Re: *Re-Opened Record (Tree Felling Permit)*
Applicant: Springfield Utility Board
City File No. 811-19-000016-TYP 2
Project Name: SUB Glenwood Substation and Transmission Line Tree
Felling Permit
Our File No.: 13538/12953

RE: REVIEW OF FEI 7/24/19 SUBMISSION, SUB POWER LINE, E 22ND AVENUE.

RE: SLOPE STABILITY CONCERNS, SUB POWER LINE, VICINITY OF E 22ND AVENUE

SUB E. 22nd Avenue Substation Project Slope Stability Review
Figure 3: Portion of Eugene East and West Quadrangles Geologic Map
 Base from Madin and Murray, DOGAMI, 2005.

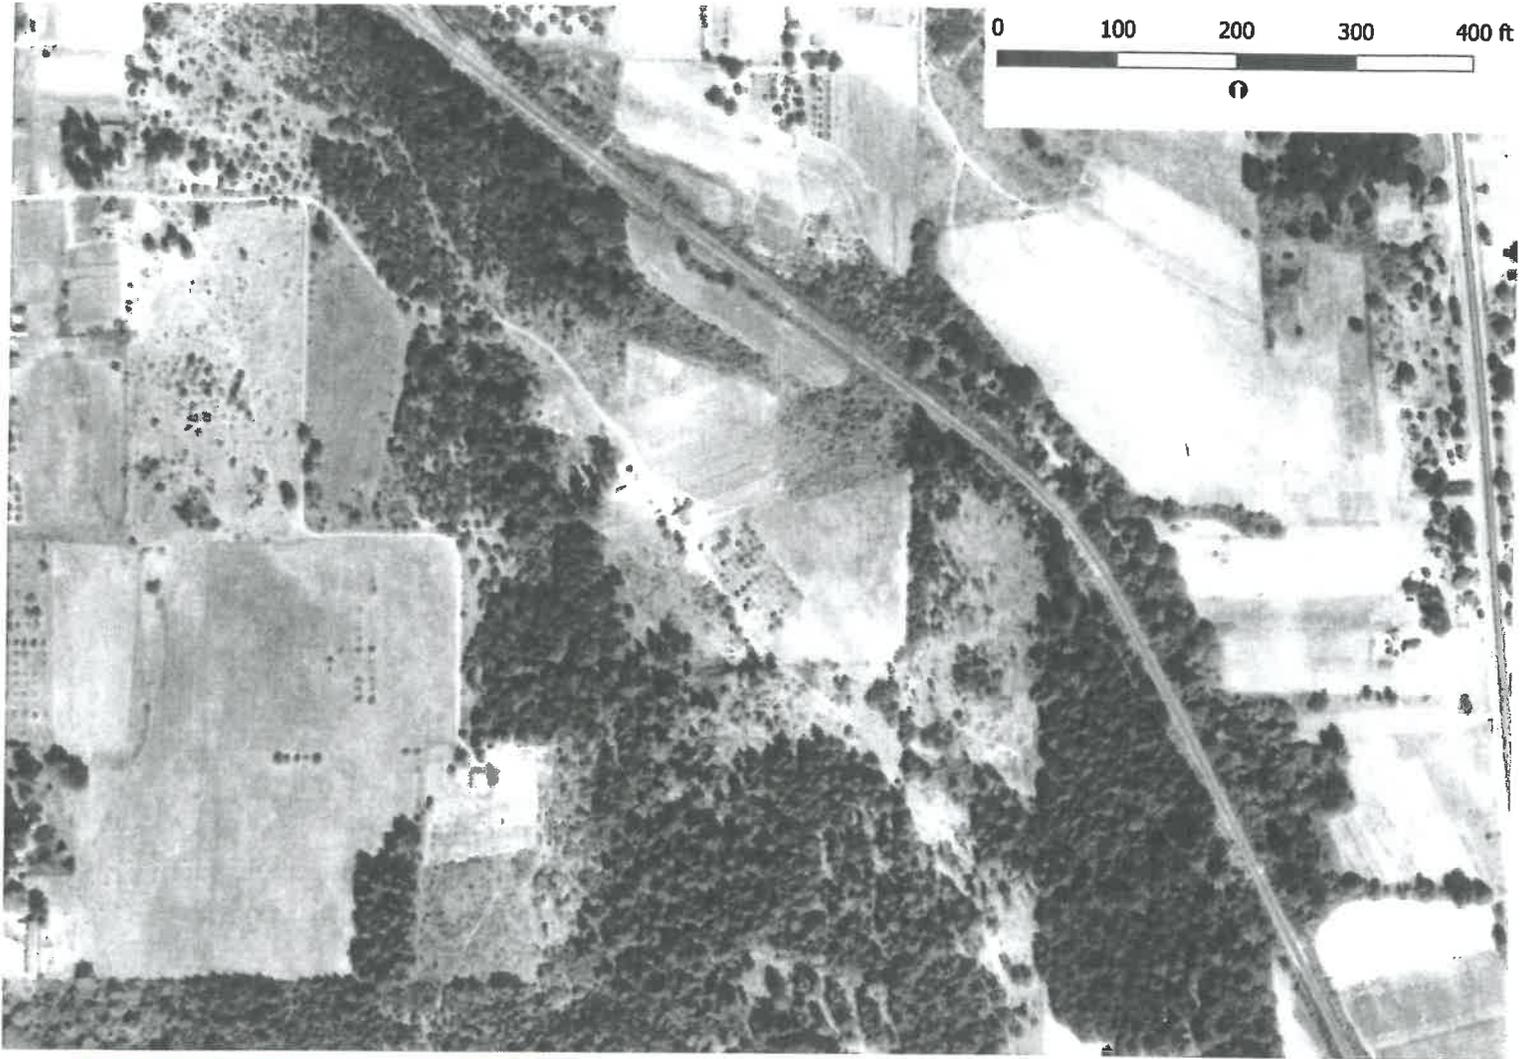
The *Preliminary Geologic Map of the Eugene East and West Quadrangles, Lane County, Oregon* (Madin and Murray, DOGAMI, 2005) indicates that the area is underlain by the late Eocene - early Oligocene *Eugene Formation*, which consists of shallow marine sandstone and siltstone with local/minor conglomerate beds. In the vicinity of the site, the map shows generally northeasterly to southeasterly dips ranging from 9 to 15° with a dip of 13° to the ENE directly at the site (Figure 3). A basalt body is shown to be present not far south of the project area.

SUB E. 22nd Avenue Substation Project Slope Stability Review
Figure 4: 1936 Air Photo w/o Annotations
Base from 1936 Willamette Valley Project, Photo 3888.

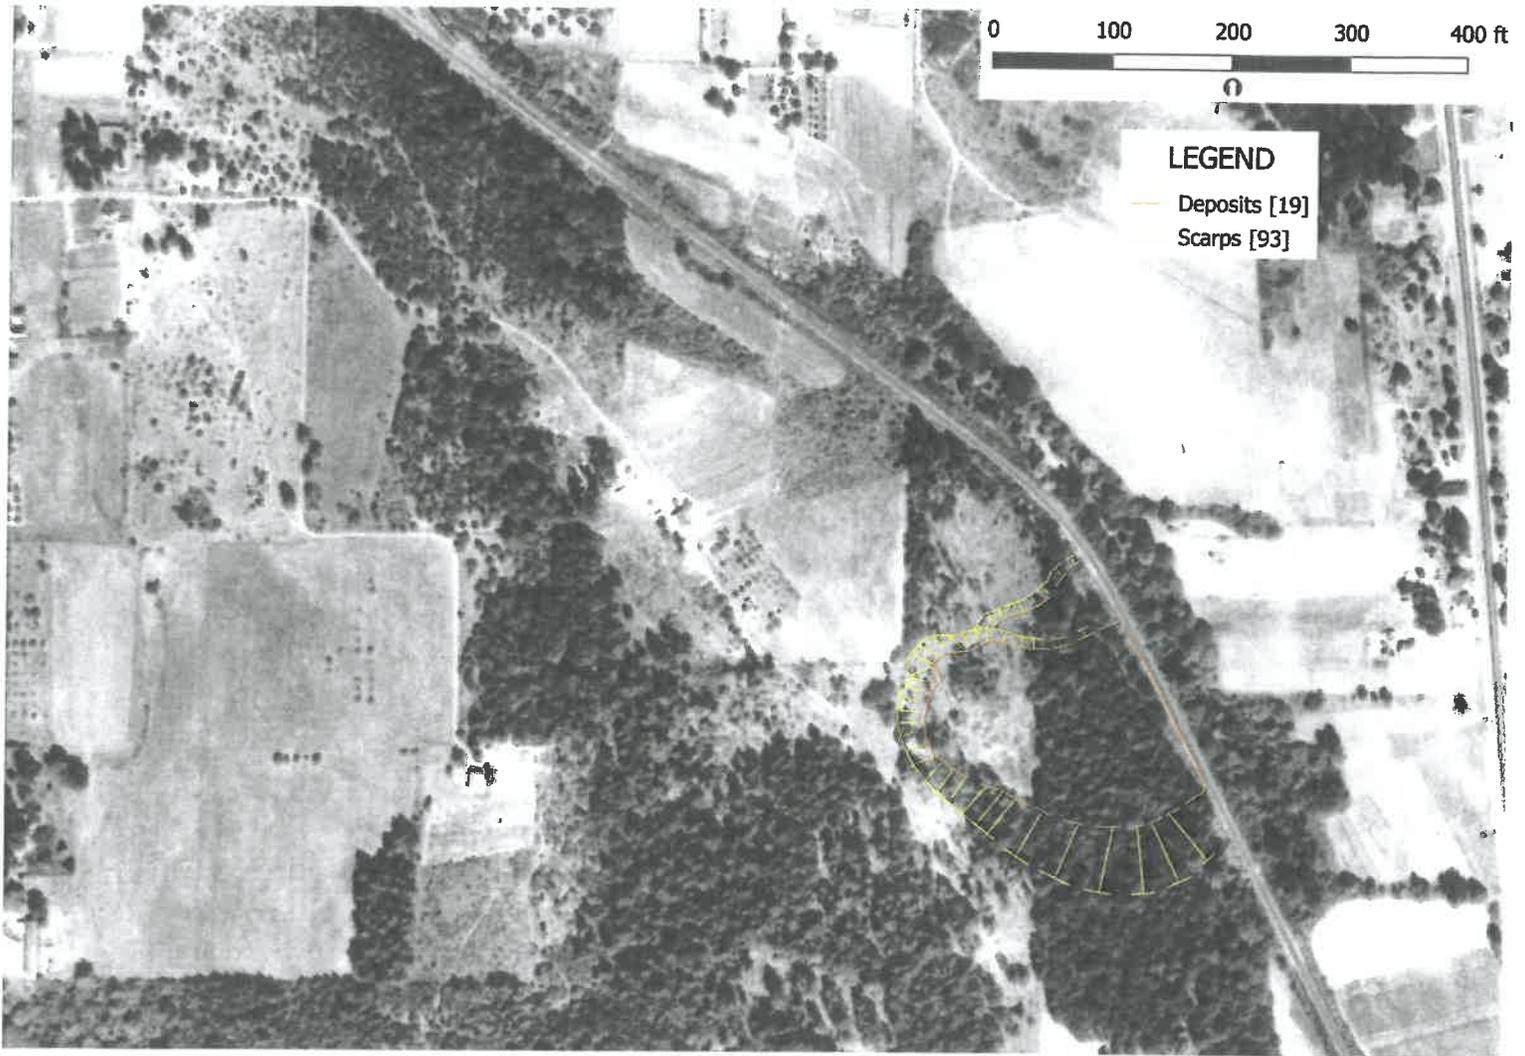
At the time, the entire northern portion of the project site was without tree cover, and appears to have been used to grow hay or grain (Figure 4a). The western portion of the southern extension of the power line had been recently logged. A relatively dense fir forest covered the lower slopes of the amphitheater-shaped slope in the southern portion, and the hill on which the EWEB power line has now been constructed.

SUB E. 22nd Avenue Substation Project Slope Stability Review
Figure 4b: Portion of 1936 Aerial Photo Showing Probable Landslide Feature
Base from 1936 Willamette Valley Project, Photo 3888.

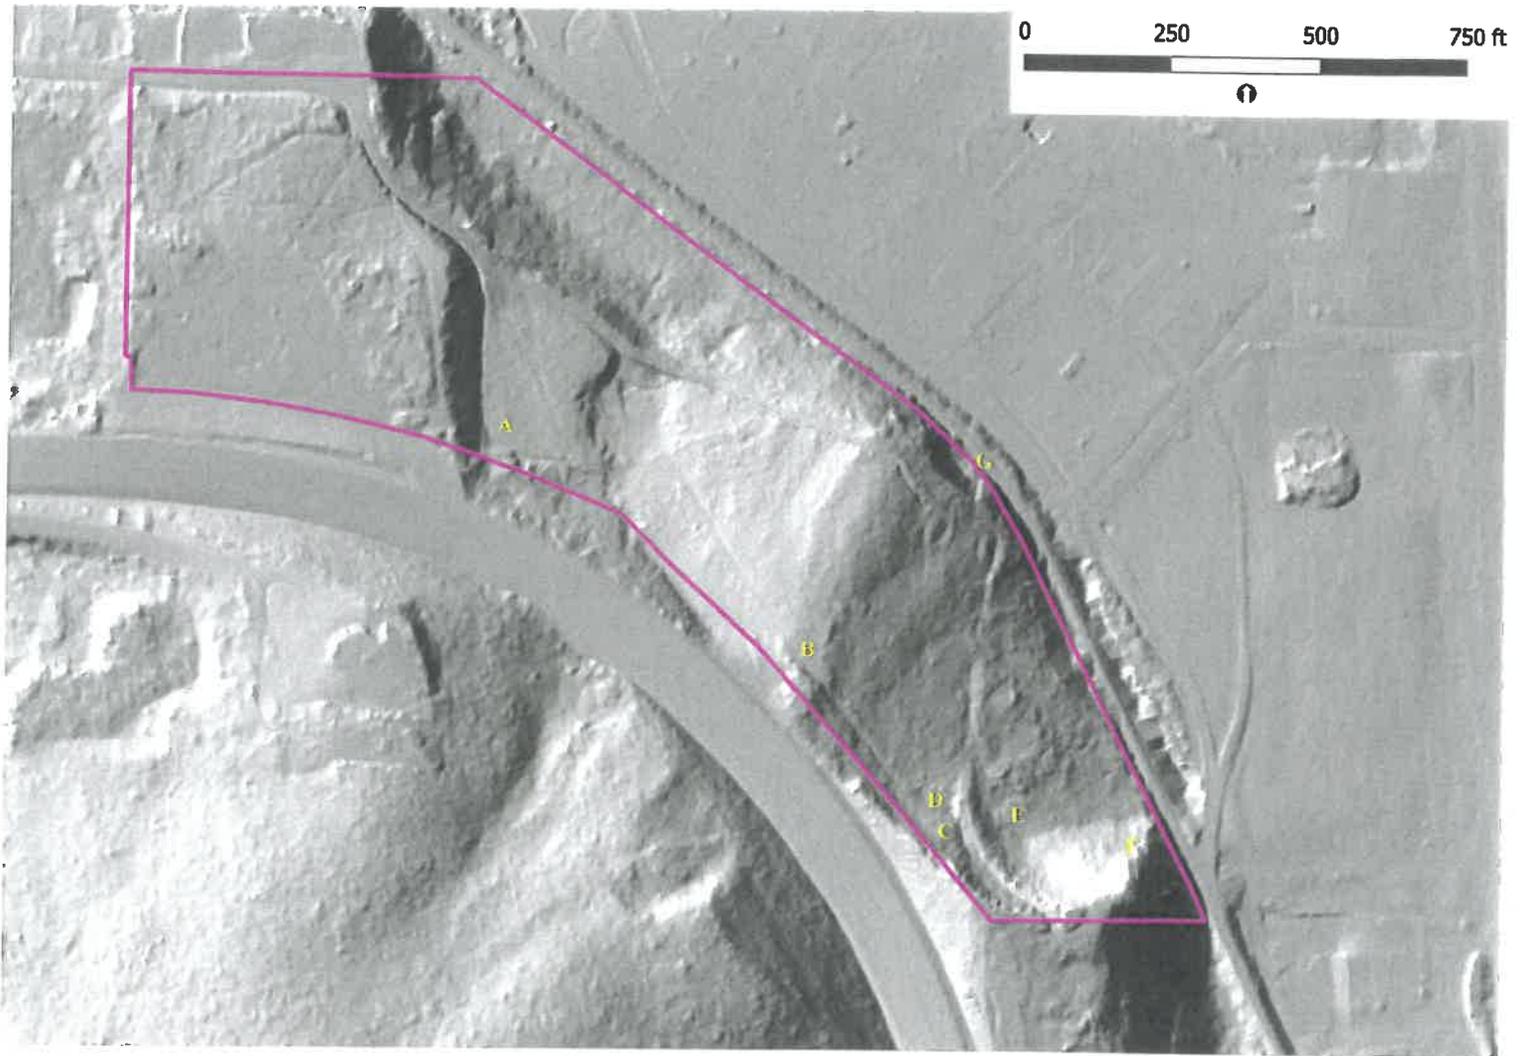
Soil disturbance is evident along the central (westernmost) upper edges of the amphitheater-shaped slope which is proposed to be clear-cut and then traversed by the southern portion of the power line (Figure 4b). Two further lines of soil disturbance extend from that area towards the east-northeast. Apparent raveling of the cut bank on the west side of the railroad tracks is discernible where these lines of soil disturbance would “exit” the toe of the slope. Tree cover obscures much of the ground in the southern and eastern portion of the area of interest and the area upslope (W) from the current location of I-5.

These observations show that the concave, amphitheater-shaped slope in the southern portion of the proposed project is a natural feature, as opposed to having a man-made origin. Given the geomorphology of this feature, with an arcuate steeper slope segment as its upslope boundary, lacking a well-defined creek channel, and having a gently sloping depressed central area is typical of deep-seated slope movements in this area.
